SUBJECT: **To set a Public Hearing for Final Site Plan & Special Land Use Permit Amendment at 203 Pierce – Toast Birmingham**

SUBJECT: **Report for Final Site Plan & Special Land Use Permit Amendment 203 Pierce – Toast Birmingham**

Proposed Outdoor Dining Platform

Plan

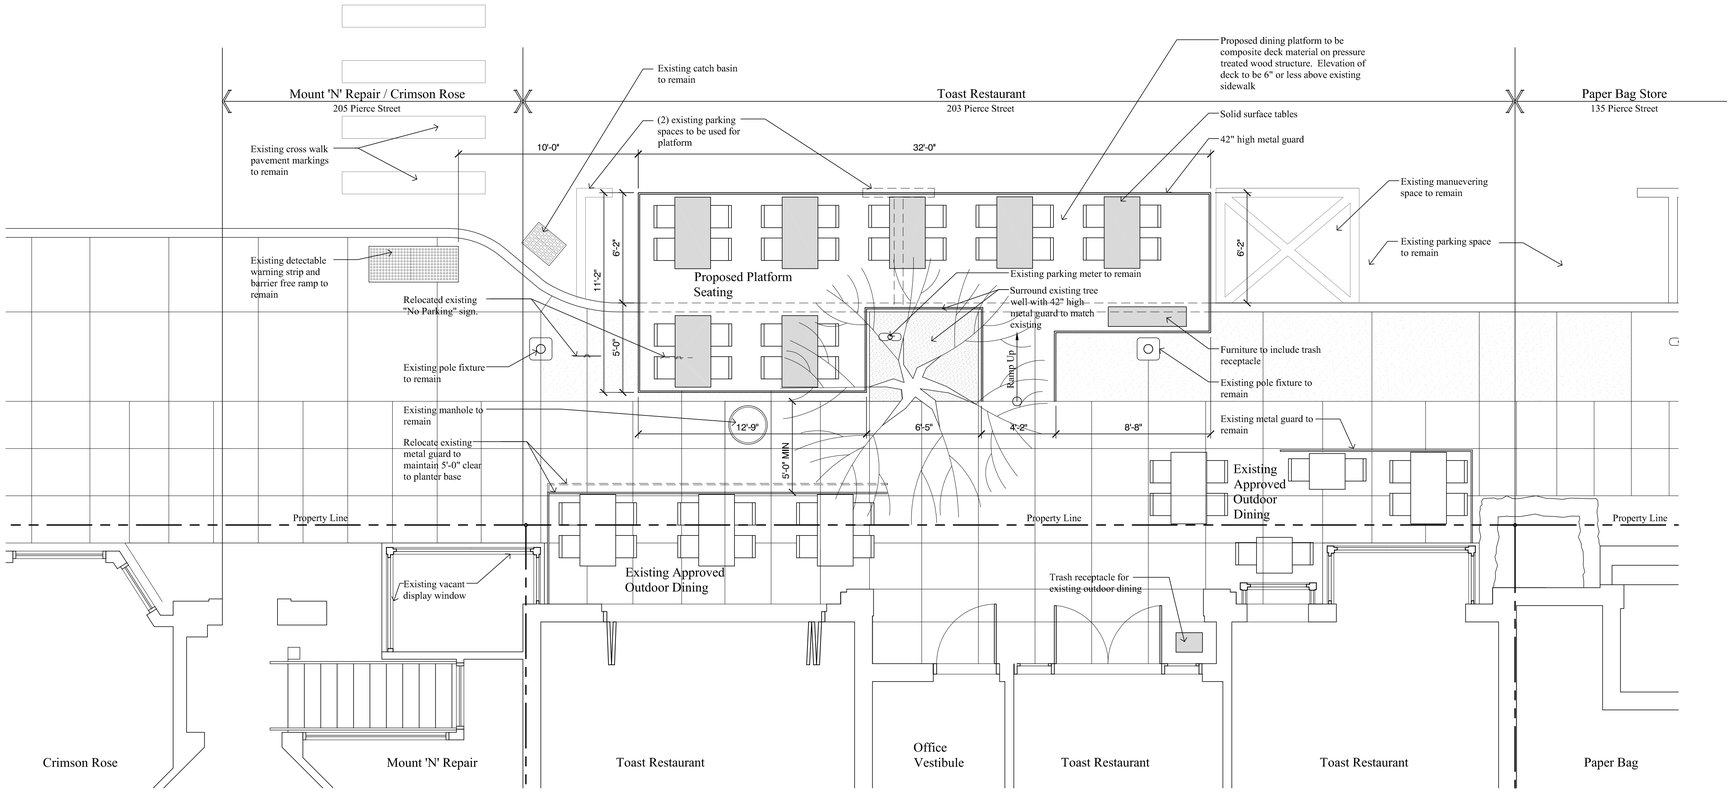
4.4 Pedestrian Access & Circulation – Pedestrian access to the outdoor café is available directly from the City sidewalk. Under the 2016 Plan, outdoor cafes are encouraged as they create a more pedestrian friendly environment. All outdoor dining areas must maintain a 5 foot minimum width of unobstructed pedestrian access along the storefront in the public right-of-way, however as mentioned above, the Planning Board has determined that each applicant would be reviewed on a case by case basis to determine the existing pedestrian traffic flow. The proposed layout does provide for outdoor seating along the storefront, as well as on a platform extending into two parking spaces along Pierce as recommended in the 2016 Plan. **The required 5' pedestrian path has been provided along the sidewalk except in the area of the existing tree well. The applicant will be required to provide the required 5' walk by removing tables or adding an ADA compliant tree grate to the tree well.**

1. Need a detail of the proposed guardrail to review.
2. Handrails required on the ramp

The applicant is proposing to add a new outdoor dining platform in front of the building, along Pierce Street, in addition to the existing sidewalk dining area along the face of the building. Both outdoor dining areas are proposed to be enclosed with 3' powder coated aluminum railings painted black. **A 5' pedestrian pathway, which is required, has been provided along the sidewalk except in the area of the existing tree well. The applicant will be required to provide the required 5' walk by removing tables or adding an ADA compliant tree grate to the tree well.**

The outdoor dining area as proposed does not provide for safe and efficient pedestrian flow as a continuous 5' wide pathway is not proposed between the platform and the seating located against the building. The 2016 Plan recommends that this pedestrian way be immediately adjacent to the storefront to allow pedestrians to see into the storefront and to have a consistent and unobstructed walkway. However, the Planning Board has discussed where the location of the

(1) The applicant provide the required 5' walk by removing tables or adding an ADA compliant tree grate to the tree well;
(2) The applicant add trash receptacles to both outdoor dining areas;
(3) The applicant provide appropriate details on the platform guardrail and handrails on the ramp to the platform to ensure compliance with the requirements of the Building Division;
(4) The applicant pay for the removal and re-installment of the parking meter where the outdoor dining platform is located;
(5) The applicant execute a revised contract with the City and obtain an outdoor dining permit.

(1) The applicant provide the required 5 ft. walk by adding an ADA compliant city standard tree grate to the tree well;
(2) The applicant add trash receptacles to both outdoor dining areas subject to administrative approval;
(3) The applicant provide appropriate details on the platform guardrail and handrails on the ramp to the platform to ensure compliance with the requirements of the Building Division;
(4) The applicant pay for the removal and re-installment of the parking meter where the outdoor dining platform is located;
(5) The applicant execute a revised contract with the City and obtain an outdoor dining permit; and
(6) The applicant is allowed to change the north table seating arrangement to a one table setup with administrative approval.
